**RECREATIONAL VEHICLE
SAFETY RECALL NOTICE**

Safety Recall: 23V-822
Safety Advisory: 23-447
January 23, 2024

Figure 1

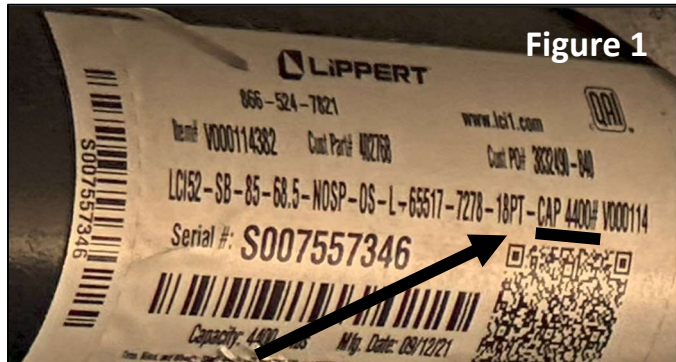
It has been decided that the vehicles in the recall population may have axle springs rated at 4400 pounds rather than the 5100 pound axle rating as specified on Federal Identification Tag. The axles installed had the wrong size springs. Under certain conditions during travel, undersized axle springs can be overloaded leading to an increased risk of axle spring failure and increasing the risk of a crash.

You may choose to self-inspect the axle's tags. If the tag reads as CAP 4400#, as shown in Figure 1, as soon as possible, please make an appointment to have your RV serviced by your dealership. Customers should unload all cargo and empty holding tanks (fresh water, grey water, black water, and water heater) and take their unit to an authorized dealer for remedy of the incorrectly installed axles springs. The labor time to perform this correction is approximately 1 ½ hours. Please ask your dealer if you wish to know how much additional time will be needed to schedule and process your RV for this repair.

Keystone representatives have been in contact with the staff at your selling dealership regarding this situation. The remedy is to replace under rated 4400 LB springs with the correct size 5100 LB springs. This would require both 2200 LB springs be replaced. The service and parts required for this corrective action will be provided at no charge to you.
